# Access Compliance Report

## Public Rights-of-Way

| Intersection ID: 49130                  | Main Street: AUBURN_HILL_LN | Cross Street: WILTSHIRE_RIDGE_RD        | Location: SW           |
| ADA ID: 00576E8CD71B                    | Ramp Type: Perp             | Initial Pass/Fail: Fail                 | Overall Compliance: No |

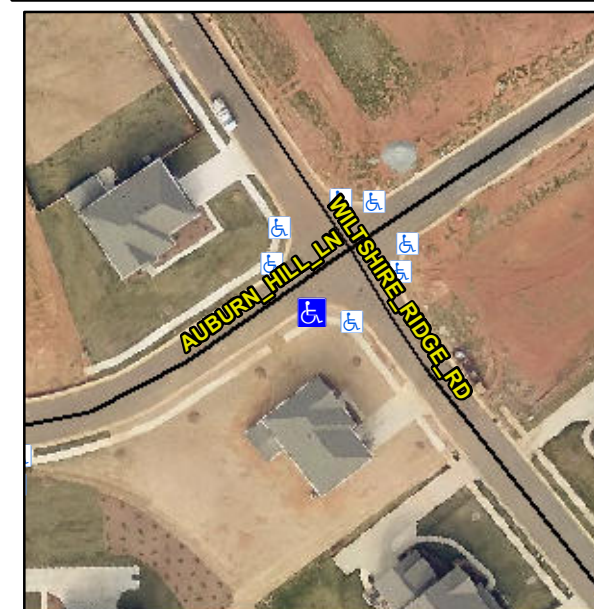
**Remove & Replace Entire Ramp.**

**Not Found, R304.5.1**

| Compliance | Description           | Data | Compliance | Description                 | Data |
|------------|-----------------------|------|------------|-----------------------------|------|
| No         | Ramp Width (in)       | 47.0 | Yes        | Ramp XSlope (%)             | 0.2  |
